# ADDENDUM NO. 1

## Boquet River Non-Point Source Pollution Improvement Project – Phase II

Town of Willsboro, New York

March 28, 2018

FORMER WILLSBORO PULP MILL (NOW DEMOLISHED)

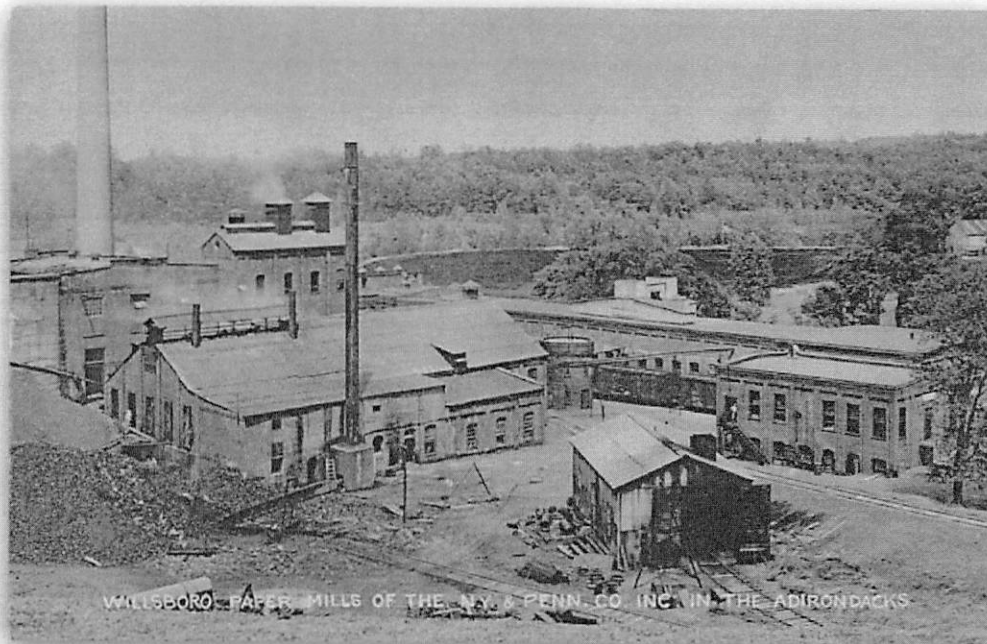
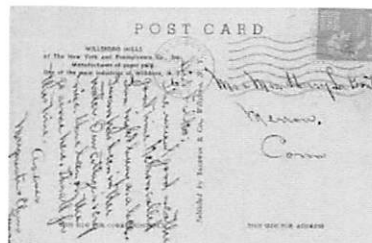
6. The Engineer's Estimate for the project is between \$200,000 and \$300,000.
7. In response to a question from a prospective bidder seeking clarification regarding the railings: The details on sheet D.1 for the ramp shall be a 3-rail fence plus a handrail in accordance with details B/D.1 and C/D.1 for OSHA low use. Alternative proposals for the railing and how it is anchored will be accepted that provide equivalent safety in the interest of reducing cost. The railing on the fishing platform shall be anchored in accordance with the details and notes on sheet S1.0. The railing itself shall be painted metal (galvanized or not) and shall resemble the railing at the former fish ladder at the former site of the dam (pictures attached).
